DEEP LIFE OPEN REVOLUTION FAMILY OF REBREATHERS

Failure Mode, Effect and Criticality Analysis Volume 3:

Electronics Failure Mode Review

DOCUMENT: FMECA_OR_V3_Elec_FMA_090529
[Filename]

Figure 1: Simplified Circuit to prevent FPGA blocking uC and visa versa

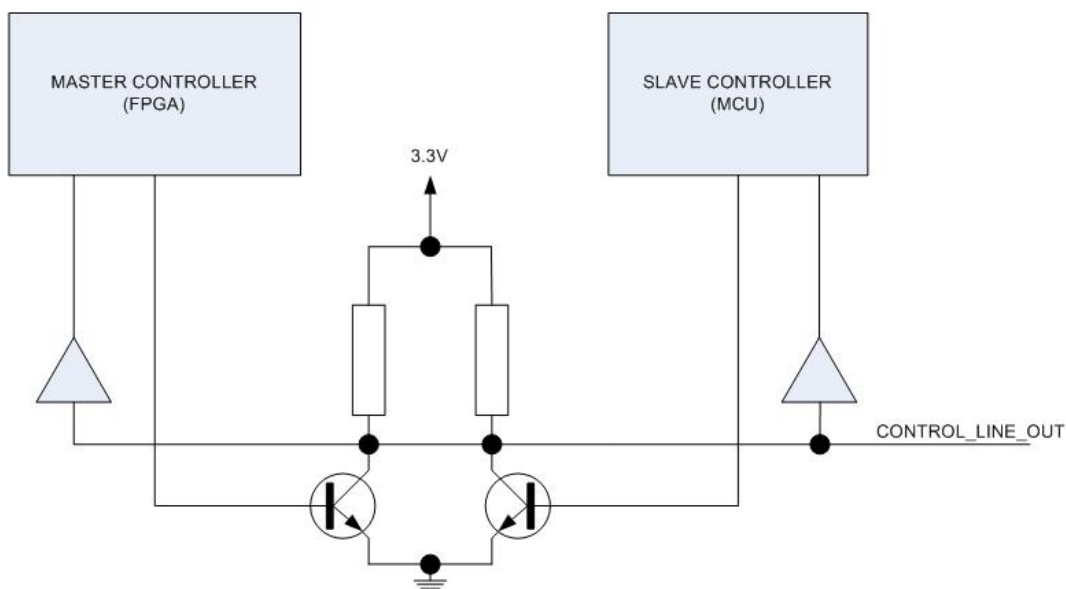
The problem addressed by this circuitry is that if the uC fails, or the FPGA fails, then the outputs can be in a state that blocks the ADC or the injector. The uControllers in common use in dive systems have an MTBF of only 60k to 100k hours. This is a grave risk, that requires use of parallel FPGA and uC: which is what the design under review uses, to reduce the overall MTBF better than 6 billion hours.

A circuit acting as a set of Exor gates allows the uC to disable the FPGA and FPGA to disable the uC when either fails in a state which blocks the outputs. That is the FPGA monitors the uC and the uC monitors the FPGA, and if either fails, then the working circuit will disable the outputs of the failed circuit, using a circuit arrangement such that a failing circuit cannot block a good circuit (the circuit only has to block the active state, and if the active state is the inverse of the normal failure state, then the whole arrangement is fail safe).

This circuit uses many Exor gates. While Exor gates are cheap, they take up space and create extra failure points.

Decision: After discussion, a simpler circuit as shown in Figure 1 below, should be adopted.
